Historic Architectural Review Commission Staff Report for Item 5

Application Number: H2023-0011

Address: 818 Eaton Street

Demolition of non-historic structure.

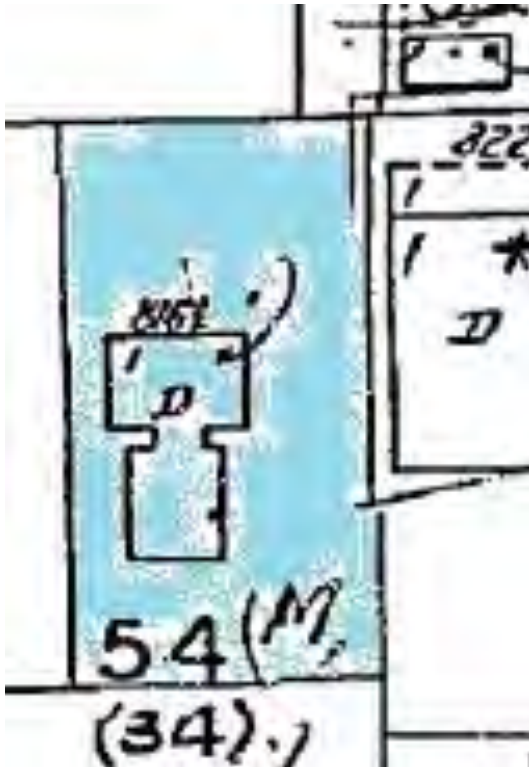
The site under review used to be known as 4 Lopez Lane and recently its address was changed as there is no real access to the property through the lane, but through Eaton Street. The existing one-story single-family building is a non-historic non-contributing structure. 1962 Sanborn Map depicts a structure 816 ½ Eaton Street in the lot, but the current building location and building configuration differs from the Sanborn Map. No photographs from 1965 were found for the building.

Although the Property Appraisers records indicate that the building was built in 1905, Sanborn Maps do not support this date.
